APPENDIX R

Comments on the Draft EIS and Responses

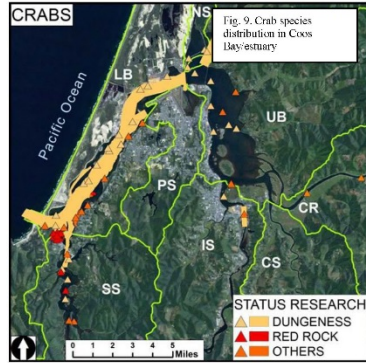
Other invertebrates affected by dredging of the navigation channel would be the species of crabs that use the area (Fig. 9 below). The crabs are harvested by recreational anglers, and they also play an important role as a food source for various other species. Large numbers of crab larvae (megalops) are in the bay in late spring and early summer and are found offshore at that time of year. They settle, and in fall they would be particularly vulnerable to dredging activities. Many of the regions that are proposed for dredging and are likely affected by the actions of dredging are important parts of the food base for fish and wildlife, as well as for human harvest. The direct impact of habitat disruption and elimination would be substantial, and the cumulative impacts of creating deep water habitats where there were more shallow beds and sandy shoals are not addressed at all. These shallow areas are used for a variety of fish species including flatfish and migrating salmonid smolts.

The DEIS states "Based on 1978 maps of shellfish (Gaumer et al. 1978), shrimp, soft shell calms, bentnose clams, and cockles are located within the intertidal areas near the slip and within dredge areas (west of the Roseburg Forest Products Company site). The four navigation channel modifications are not located in known clamming or crabbing areas, or shrimp or oyster habitat (figure 4.5-2)."

We disagree, as data regarding shellfish are provided by us in this document and are also provided in the digital resources resulting from the *Partnership for Coastal Watersheds* regarding resource distributions.

Fig. 10. Native oyster and clam s distribution in Coos Bay estuary

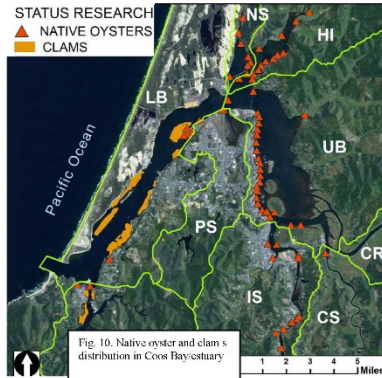
According to the recent documentation provided by the Partnership for Coastal Waters Data Sources in their Chapter 13: Clams and Native Oysters in the Coos Estuary, the area of the mitigation site near the airport is adjacent to an area with native oysters and clams (Fig. 10).

Oyster populations are highly susceptible to sedimentation effects and to toxic releases. The proposed movements of sediments from the navigation channel and facility construction would release suspended sediments that can be carried upstream and downstream of the actual area, depending on tidal influences.
